STATE PROJECT NO. 695-06-0004
FEDERAL AID PROJECT NO. 20-4(049)174
REST AREA IMPROVEMENTS, I-20 AT MOUND
ROUTE I-20
MADISON PARISH

SUBJECT: ADDENDUM NO. 2 (PLAN REVISION NO. 2 and INTERNET POSTING OF PROJECT MANUAL)

ITEMS FOR ADDENDUM – MOUNDS 23149.12

SK-1 06/08/09

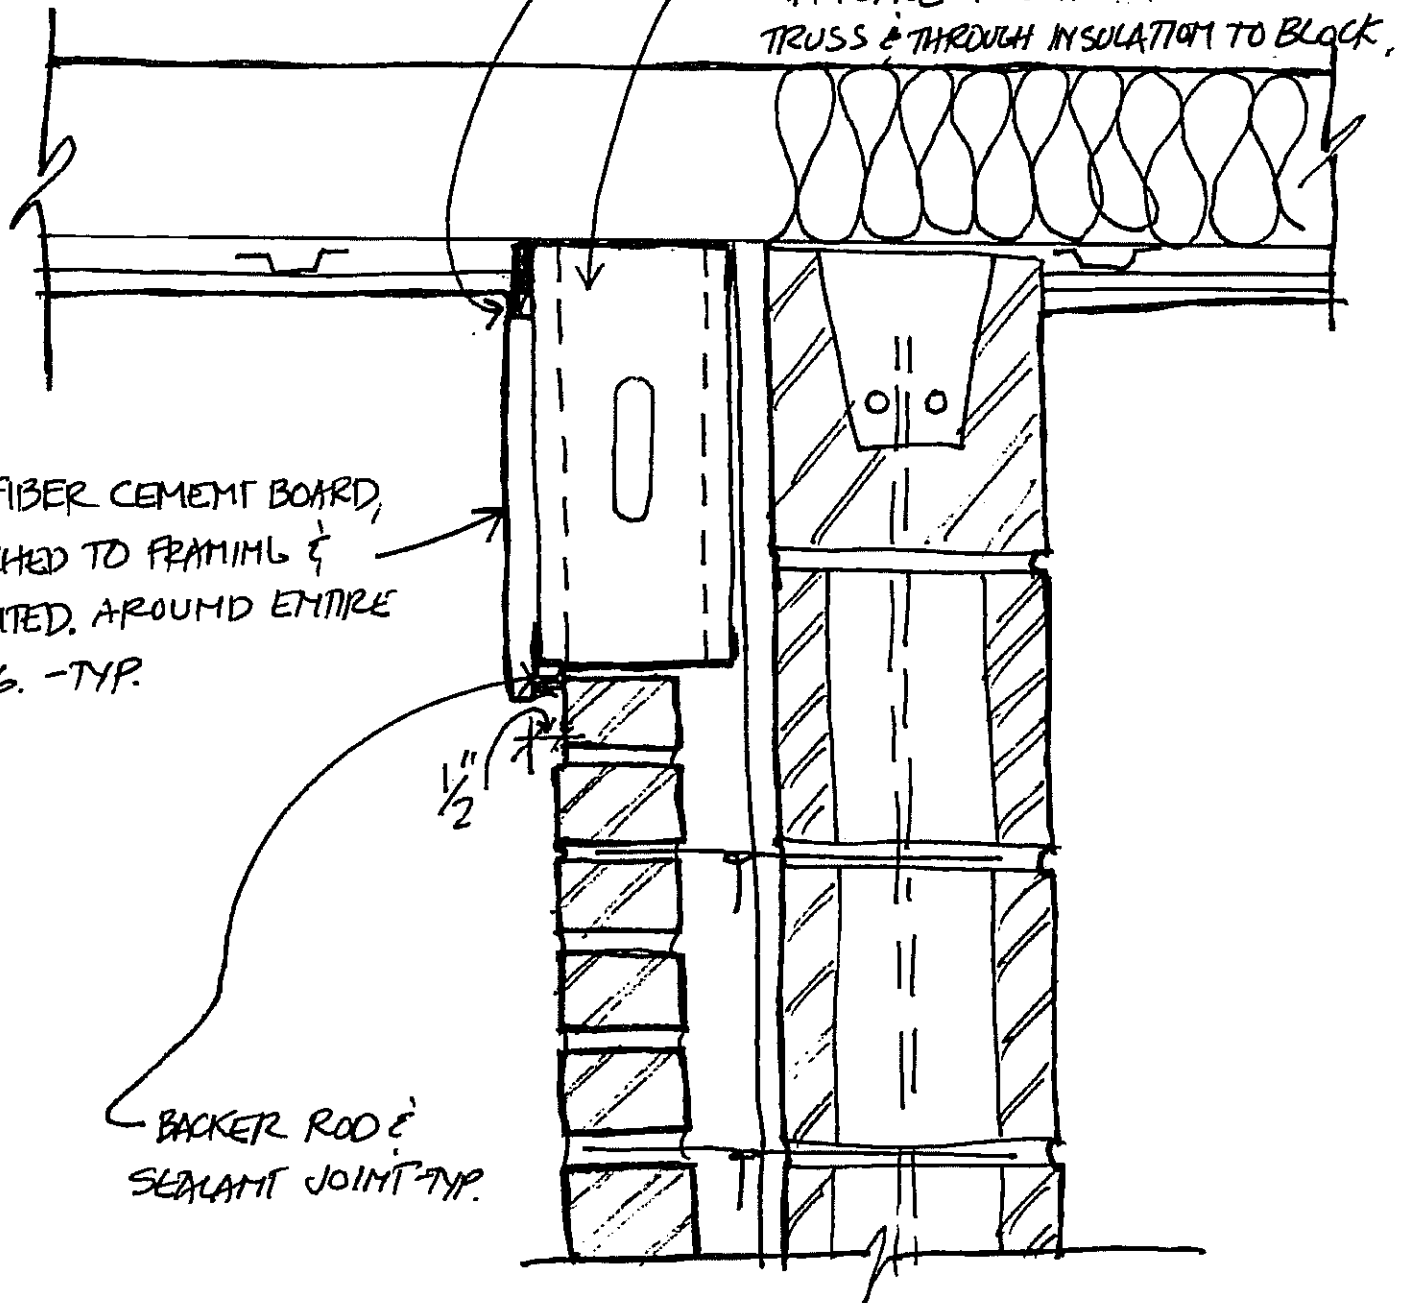
5. **Sheet 16**, drawing 4 Elevation – Building B; **DELETE** note “Stucco Beam – Typ.” and **INSERT** the following “Fiber Cement Board – Typ.”.
6. **Sheet 17**, drawing 3 Wall Section; **ADD** a revision cloud around the portion of the drawing where the soffit panel meets the brick veneer and have the cloud enclose an area including the vertical trim piece, the 8 bricks down from the truss overhang and the block backup for these brick. **REPLACE** this portion of the drawing with the attached sketch, SK-1, dated 06/08/09, attached and made part hereto.

BACKER ROD & SEALANT JT. -TYP
SIZE REQ. TO PROVIDE $\frac{1}{2}$ "
OVERHANG PAST VENEER -TYP.
GALV. MTL. STUD FRAMING,
W/TOP & BOTTOM TRACK. SECURE
IN PLACE TO BOTTOM CHORD OF
TRUSS & THROUGH INSULATION TO BLOCK.

$\frac{1}{2}$ " FIBER CEMENT BOARD,
ATTACHED TO FRAMING &
PAINTED. AROUND ENTIRE
BLDG. -TYP.

BACKER ROD &
SEALANT JOINT -TYP.
